1CAN041004

SUBJECT: Supplemental Information to Fourth 10-Year Inservice Inspection Interval
Request for Alternative ANO1-R&R-013
Repairs to the Pressurizer Instrumentation Penetrations
Arkansas Nuclear One, Unit 1
Docket No. 50-313
License No. DPR-51

Response to Requests for Additional Information

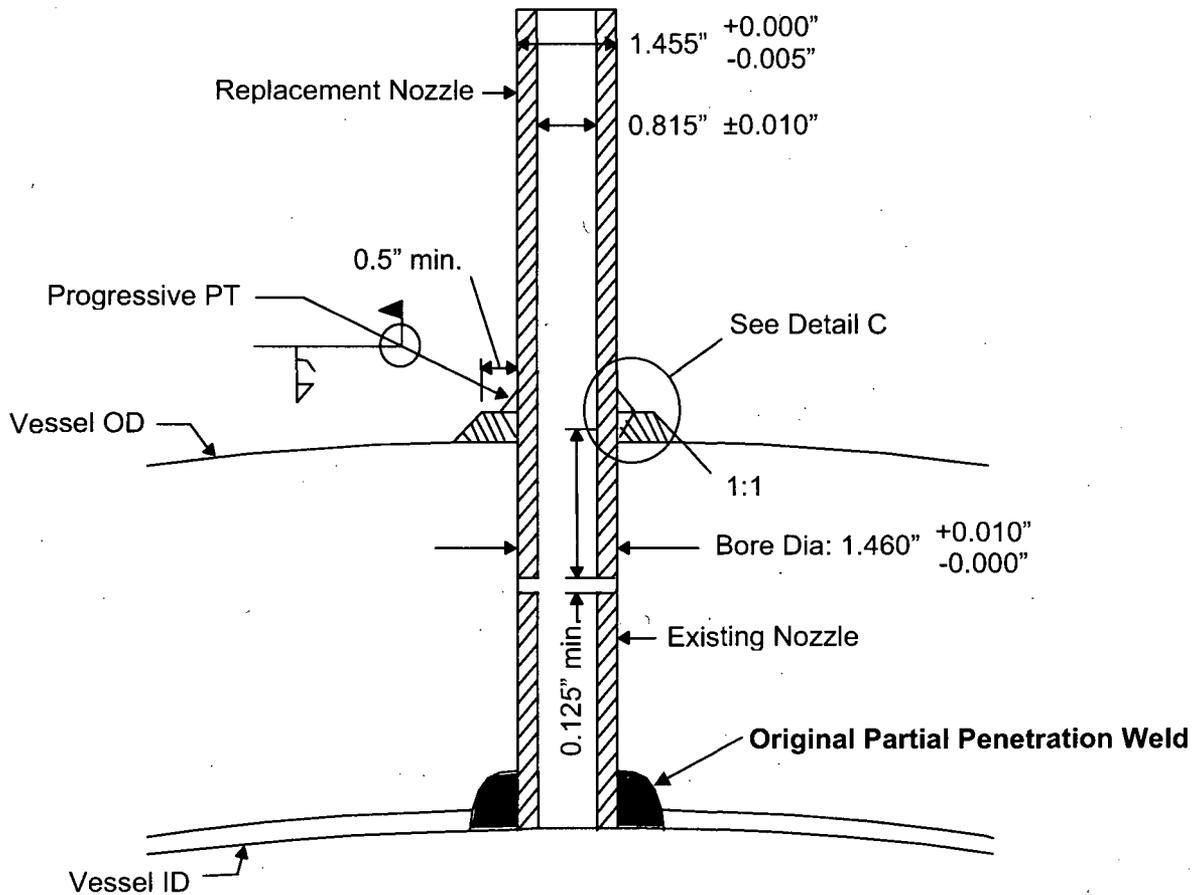
2. Section 4 states that the original partial penetration attachment weld and a remnant of the original nozzle will remain in place. Figure 1 of the relief request shows that a weld pad is installed at the outside surface of the pressurizer shell. Clarify the location of the original partial penetration attachment weld using the diagram in Figure 1 of the relief request.

The original partial penetration weld is located at the inside surface of the pressurizer between the original penetration nozzle and the pressurizer vessel, as shown on Figure 1 below.

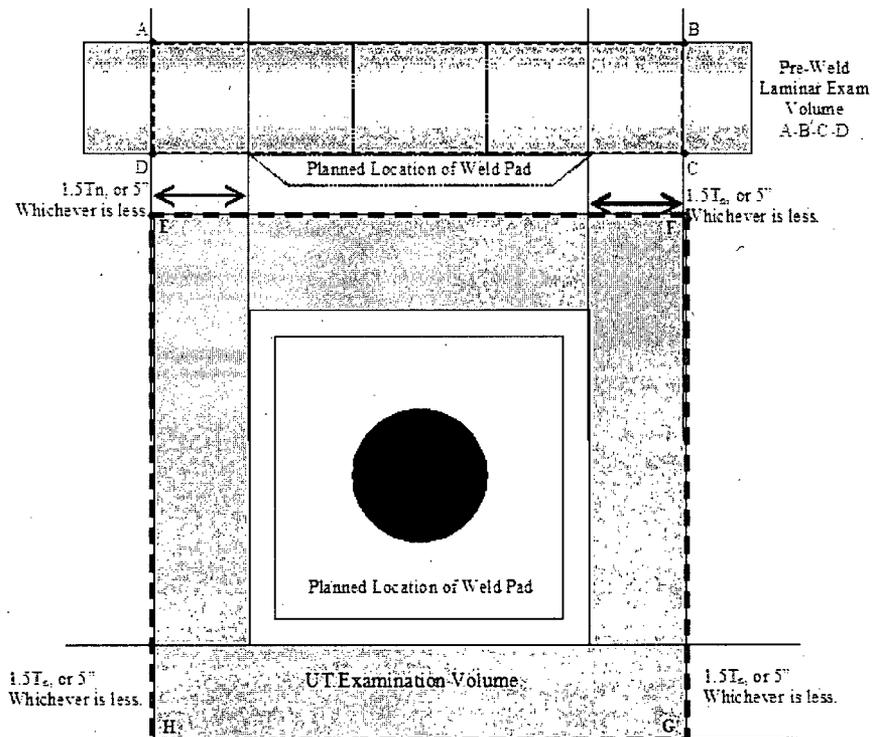
5. Page 4, Item (2), states that a surface and ultrasonic examination will be used to inspect the base metal before application of the weld pad. (1) Provide the exact surface area and volume that will be inspected (use a diagram similar to Figure 1 in the relief request to indicate the examination surface area and volume). (2) Discuss the qualification of the ultrasonic examination (reference the appropriate ASME Code section and subsections). (3) Discuss whether there be a surface and ultrasonic examination performed on the penetration bore after a portion of the original nozzle is removed. (4) Discuss whether the surface of the penetration bore will be cleaned after a portion of the original nozzle is removed and before the new nozzle is inserted.

With reference to Part (1) of the above question, the nondestructive examination procedures require examination of the weld pad location and adjacent areas prior to welding as described below:

- A. Liquid penetrant examination of the base material of the weld pad footprint and 5" around the pad location is performed. This Volume is E F G H as shown in the figure below.
- B. The base material of the weld pad footprint and 5" around the pad location is ultrasonically examined with the Phased Array laminar examination technique (-15° to +15° sectorial scan). This Volume is A B C D E F G H as shown in the figure below.
